SUNDRY NOTICES AND REPORTS ON WELLS (DO NOT USE THIS FORM FOR PROPOSALS TO DRILL OR TO DEEPEN OR PLUG BACK TO A DIFFERENT RESERVOIR. USE "APPLICATION FOR PERMIT" (FORM C-101) FOR SUCH PROPOSALS.) 1. Type of Well: Oil Well ☐ Gas Well ☒ Other ☐		WELL API NO. 30-015-33789
2. Name of Operator SOUTHWEST ROYALTIES, INC.		5. Indicate Type of Lease STATE ☒ FEE ☐
3. Address of Operator P.O. BOX 53570; MIDLAND, TEXAS 79710		6. State Oil & Gas Lease No.
4. Well Location Unit Letter D : 660 feet from the NORTH line and 660 feet from the WEST line Section 16 Township 22S Range 22E NMPM EDDY County		7. Lease Name or Unit Agreement Name STATE 16 4
11. Elevation (Show whether DR, RKB, RT, GR, etc.) 3,039' GR		8. Well Number #1
9. OGRID Number 21355		10. Pool name or Wildcat ROCKY ARROYO; CANYON

NOTICE OF INTENT TO PLUG AND ABANDON – 24 HRS NOTICE TO ARTESIA NMOC D REQUIRED

CONDITIONS FOR PLUGGING AND ABANDONMENT

Wellbore Schematic (From Surface to TD)

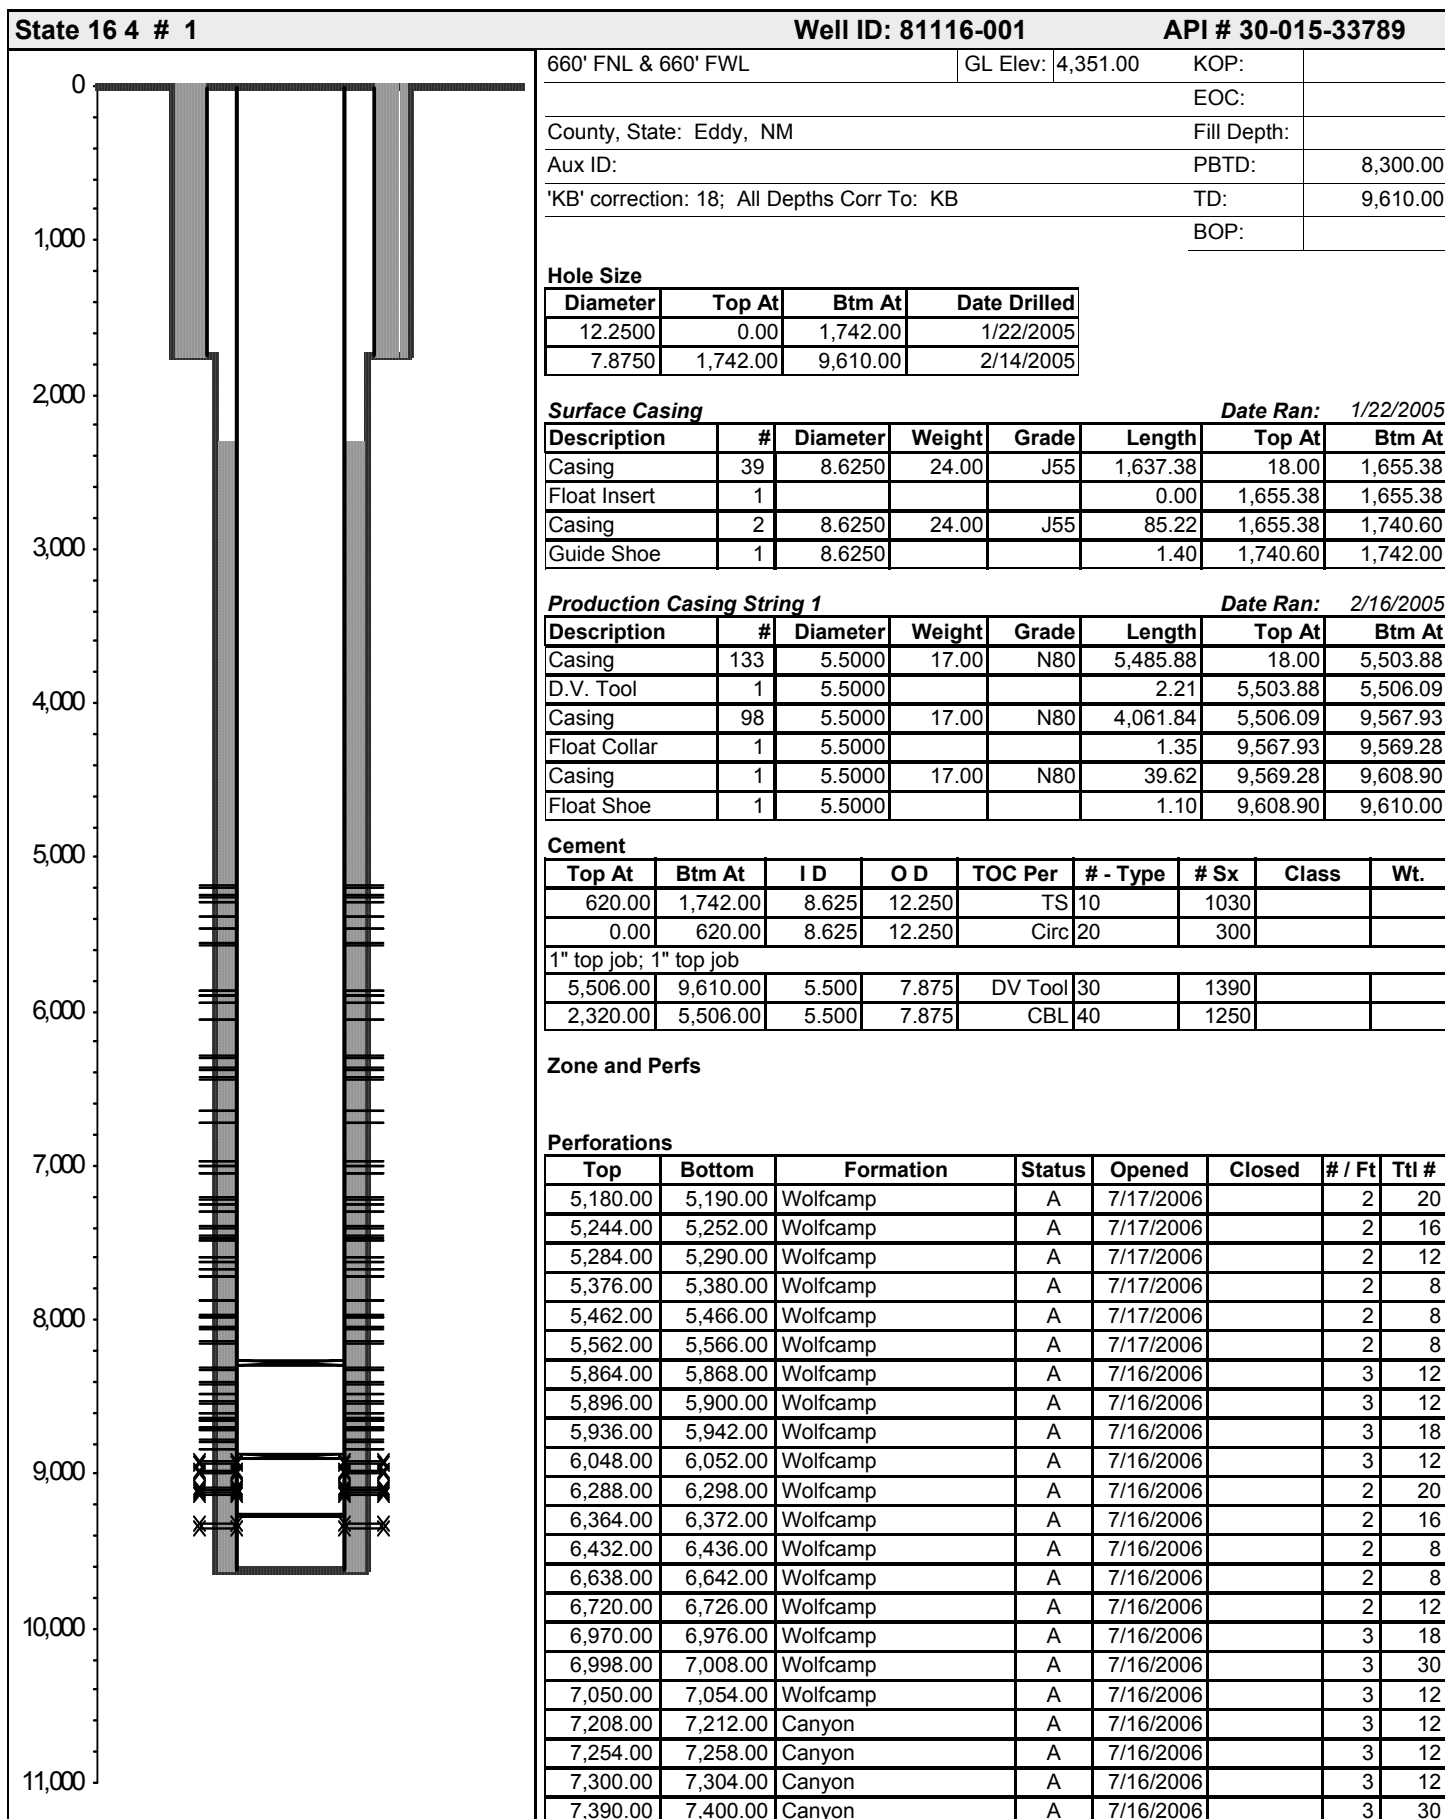
5-1/2" CSG TOC @ 2320' (CBL), Existing Plugs: CIBP @ 9260' w/ 20' cmt, CIBP @ 8900' w/ 35' cmt & CP @ 8300' w/ 2' cmt
 Spot 25 sx Cmt 8300' - WOC & Tag
 Circ MLF After CIBP @ 5080'
 Spot 25 sx Cmt @ 4900 - 4800'. T of Wcmp

Wellbore Schematic (From Surface to TD)

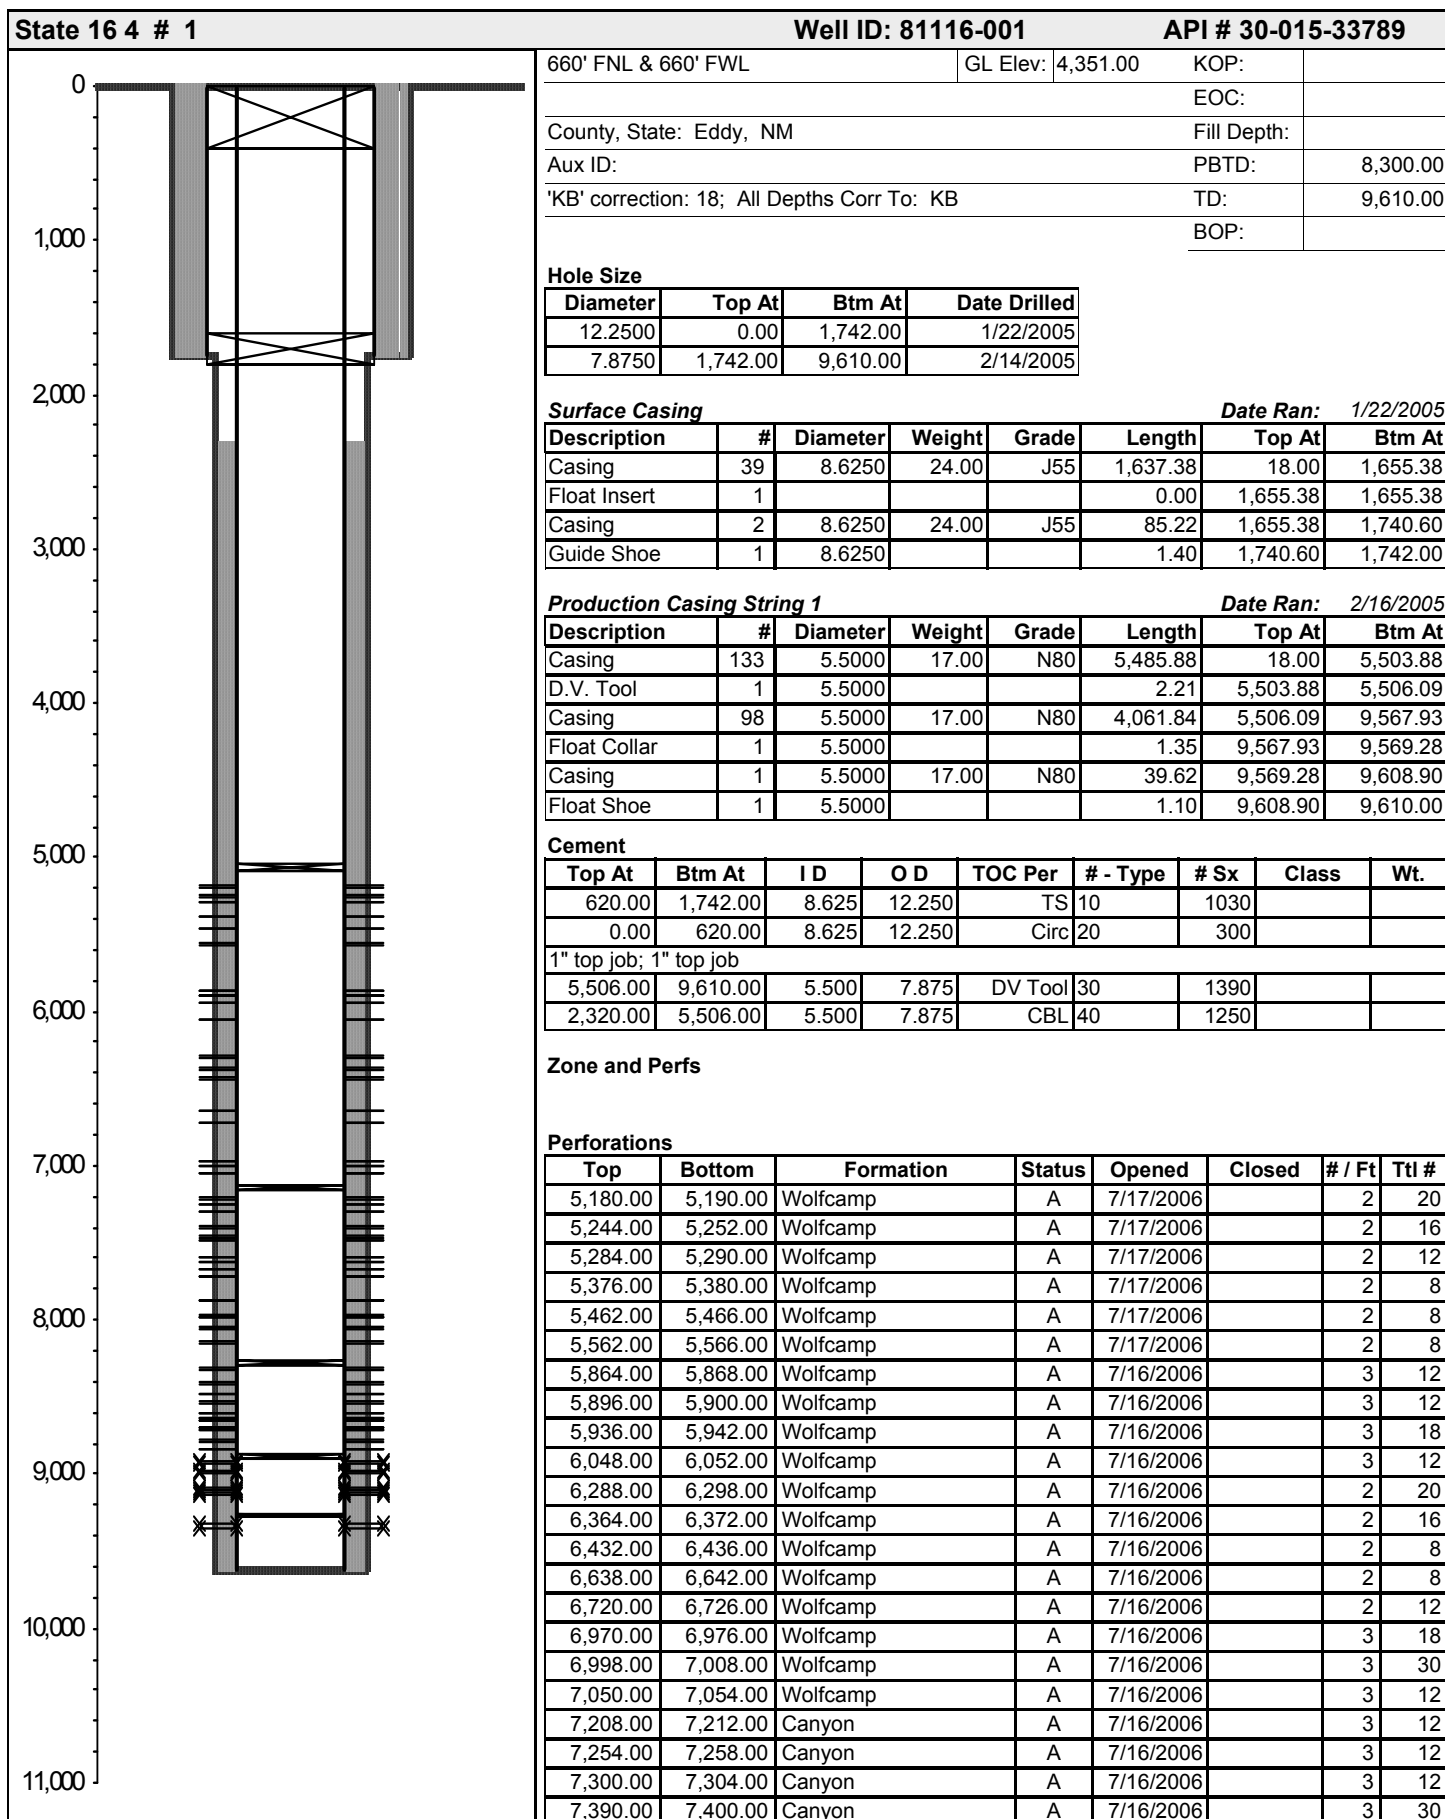
POH 2-3/8" TBG, SET CIBP @ 7158' W/ 25 SX CLASS C CMT, WOC 4 HRS & TAG, TEST TO 500 PSI, SET CIBP @ 5080' W/ 25 SX CLASS C CMT, WOC 4 HRS & TAG, TEST TO 500 PSI, CMT PLUG #1 @ 1600-1800' – SQUEEZE 35 SXS CLASS C CMT, WOC 4 HRS & TAG, CMT PLUG #2 @ 0-400' – CIRCULATE CLASS C CMT TO SURFACE
 Perf @ 1792' Perf @ 400'
